Product Change Notification

Product Change Notification: E-16-014615

PCN Date: 27-DEC-16

General Product Description:
AMPMODU MTE HEADERS GPL 296

Change in circuit cavity features

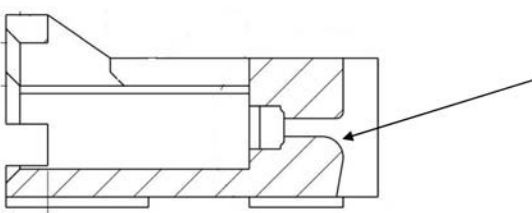
Description of Changes
To satisfy customer demand for the capability of MTE headers to handle RoHS solder temperatures, TE Connectivity has retooled the MTE header product line to use high temperature compatible LCP molding material. These changes will result in the following product changes: 1) Housing material will change from high temperature nylon to LCP. 2) The header housing width will be reduced by 0.005 inches to accommodate the assembly process. 3) In order to consolidate some housing features, the contact cavity configuration will be changed slightly as shown in the attached sketch.
